Project	13-19 Canberra Avenue, St Leonards
Report	NCC Assessment Report (Section 4.55) (2)
Reference	220225C
Date	17 December 2022
Client	Hyecorp Property Group
Contact	simon@hyecorp.com.au

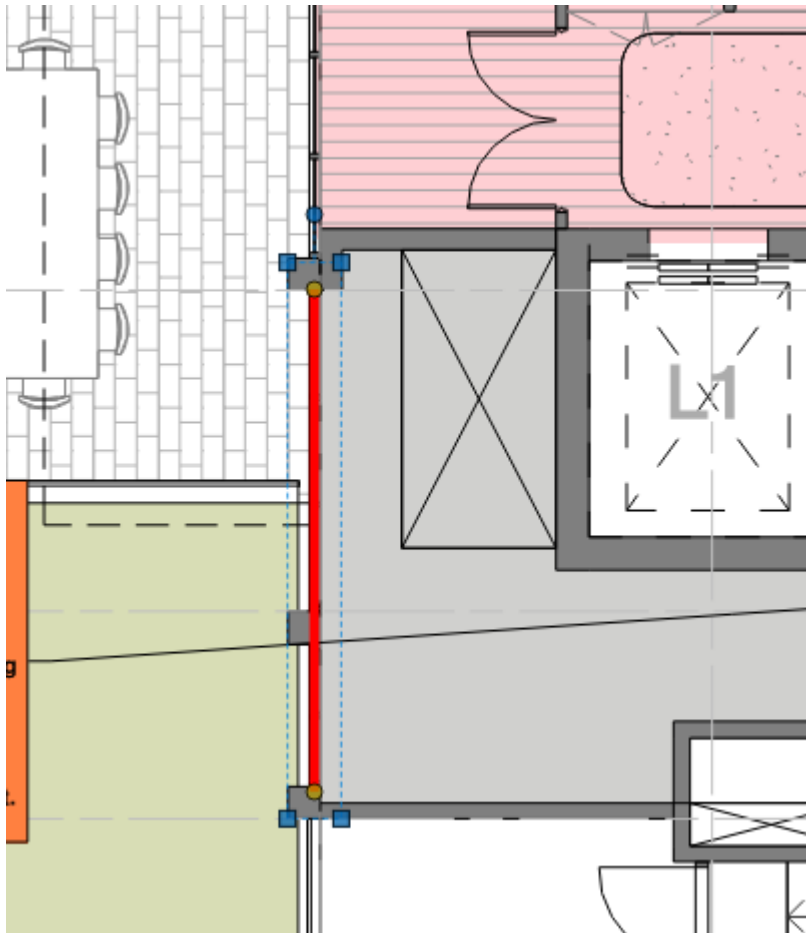
8.	Exit travel distances The following areas have been provided with non-complaint exit travel distances: <ul style="list-style-type: none"> • <u>Ground floor carpark</u> The ground floor park has been provided with a non-compliant distance to a point of choice measured to be 23m in lieu of 20m • <u>Upper ground floor</u> 	D1.4	DP4 EP2.2

Item	Possible Performance Solution	DtS Provision	Performance Requirements
	<p>The upper ground floor has been provided with a with a non-complaint distance to a point of choice from the swimming pool area, measured to be 28m in lieu of 20m</p> <ul style="list-style-type: none"> Level 1 The travel distance has been measured to be 31m to an exit from the community centre in lieu of 20m to a single exit (being the open space). Residential Levels The exit travel distances within the residential parts of the building level 2 to level 12 have been provided with a non-complaint distance measured at 10m to a point where two exits are available. <p>The exit travel distances do not meet the deemed to satisfy provisions of the NCC and must be assessed on a Performance Basis at construction stage.</p>

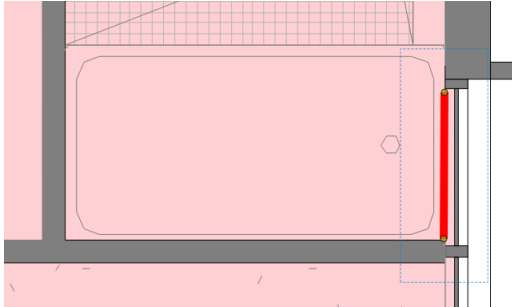
9.	<p>Distance between alternative Exits</p> <p>The distance between exits on Basement level 1 is 7.6m in lieu of 9.0m minimum</p>  <p>The distances between do not meet the deemed to satisfy provisions of the NCC and must be assessed on a Performance Basis at construction stage</p>	D1.5	DP4 EP2.2
10	<p>Travel via fire-isolated exits</p> <p>The fire-isolated stairs from the residential levels adjacent the residential lobby discharges within the entry lobby which is under the building line in lieu of discharging directly (or via a fire-isolated passageway) to a road or open space or to a part of a building in accordance with Clause D1.7(b)(ii) or D1.7 (b)(iii).</p>	D1.7	DP4 EP2.2
